City of Apalachicola

Wastewater Treatment Plant Improvements – Bid Package A

ADDENDUM NO. 2

September 26, 2025

IN-PLANT PUMP STATION PLAN

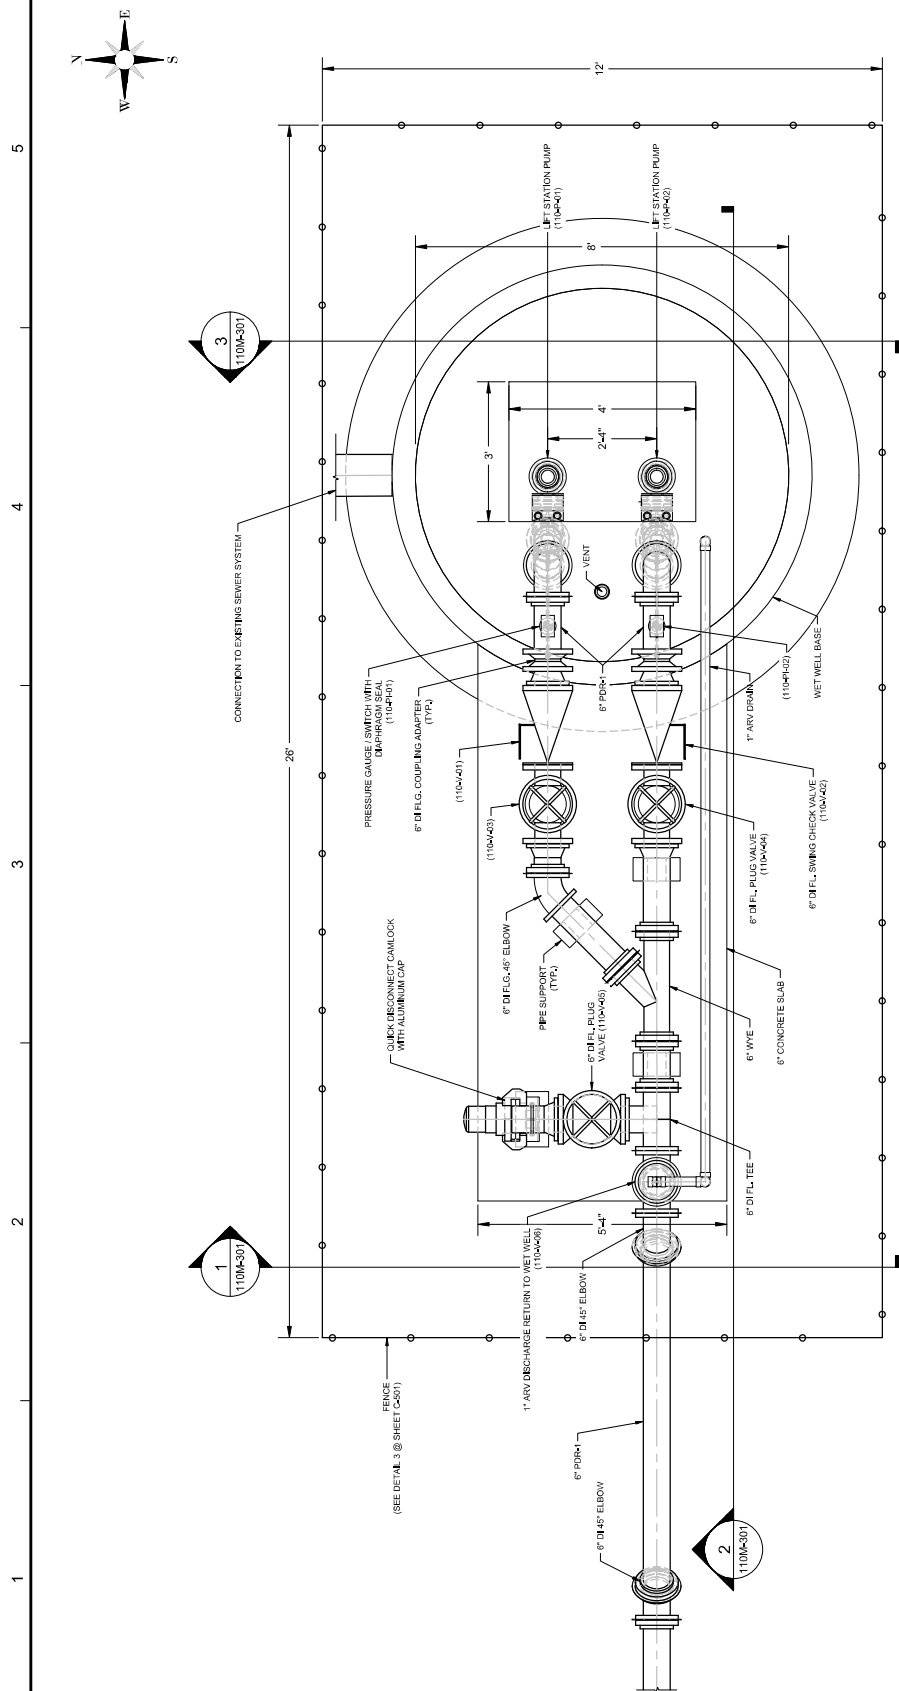
7. Note # 1 on sheet 110M-101_A mentions a valve vault and hatch, but we do not see a valve vault in the drawing. Can you confirm there is no valve vault required at the in-plant pump station?

Response: There is no valve vault at the in-plant pump station. See updated drawing 110M-101_A with valve vault language removed.

- NOTES:
1. ~~VALVE VAULT INTERIOR WALL DIMENSIONS AND HATCH FRAME OPENING DIMENSIONS TO BE -222222-~~
 2. WETWALL AND VALVE HATCHES SHALL BE US FOUNDRY, HALLIDAY (OR APPROVED EQUAL) THOTPD ALUMINUM ACCESS HATCHES. ALL HARDWARE TO BE 316 STAINLESS STEEL.
 3. FALL PROTECTION REQUIRED FOR WETWALL ~~AND VALVE VAULT~~ (SUBMITTAL REQUIRED).
 4. HATCHES TO BE EQUIPPED WITH AUTOMATIC HOLD OPEN ARMS. HORIZONTAL COMPRESSION SPRINGS, WATERTIGHT SLAM LOCKS, RECESSED OVERSIDE PADLOCK BOX, AND SAFETY CHAINS. HINGES TO BE ATTACHED USING TAMPER PROOF CARRIAGE BOLTS WITH WELDED NUTS. SHOP DRAWINGS REQUIRED FOR PRECAST WETWALL, ~~VALVE VAULT~~ AND TOP SLABS. ALL PRECAST STRUCTURES MUST MEET ASTM C478 SPECIFICATIONS.

IN-PLANT PUMP STATION SECTION

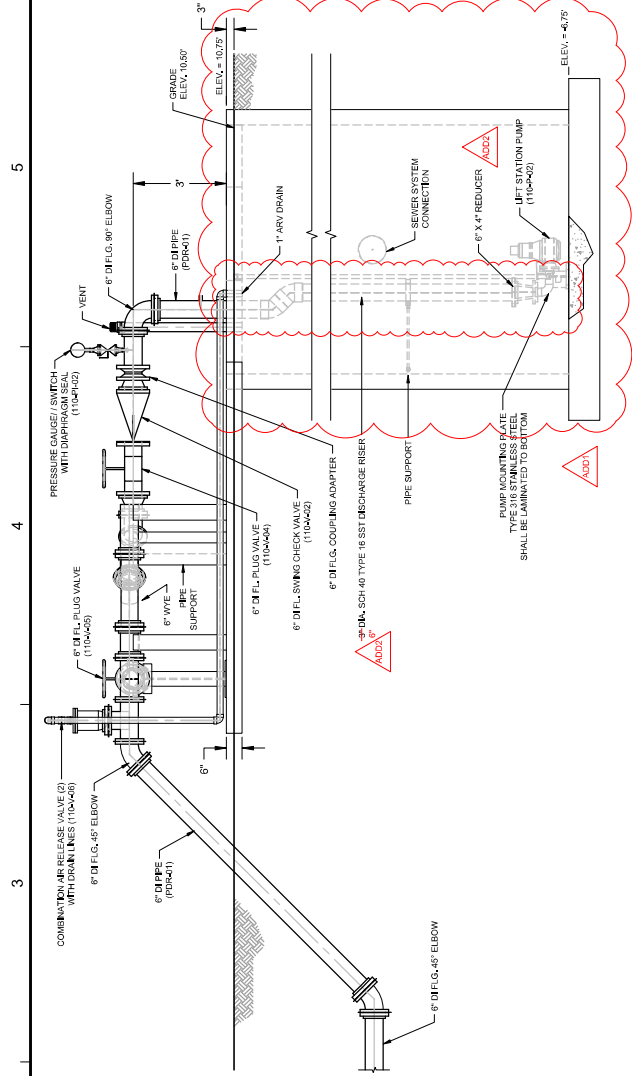
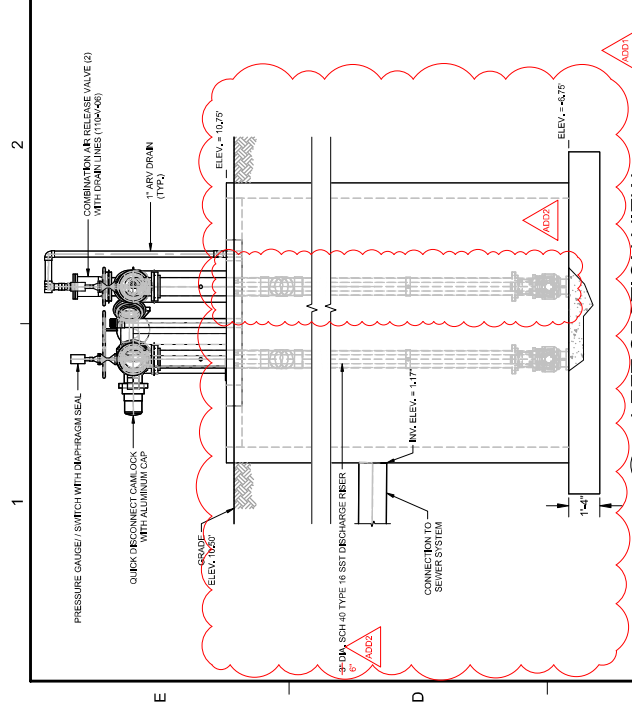
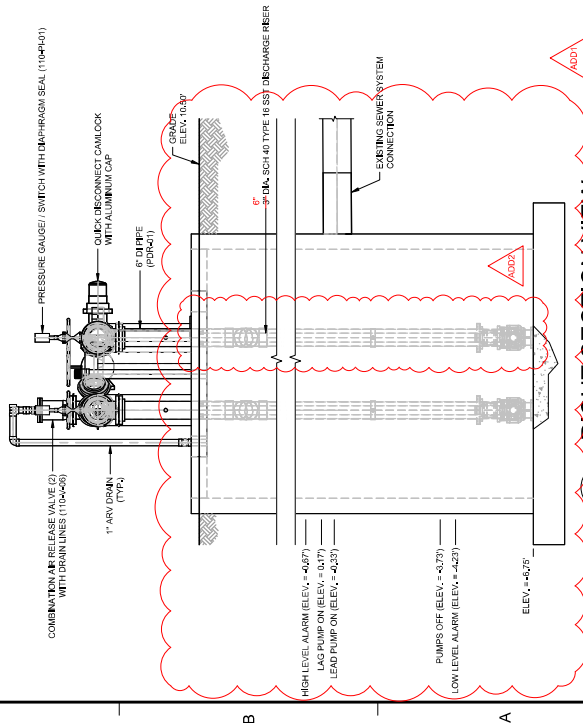
3. The drawings show a 3” riser pipe for the lift station but specify a 4” pump.

8. Addendum 01: Sheet 110M-301_A shows the top and bottom elevation of the in-plant pump station as 10.75' and -6.75'. This gives a total depth of 17.5' for the wet well. However, scaling the wet well on the drawings yields an 11.0' total depth. Can you confirm the total depth of the wet well?

Response: See updated drawing number 110M-301_A that shows 6" riser pipes.

Response: The total depth of the wet well is 17.5', the drawings show a break to fit the section views on the drawing sheet.
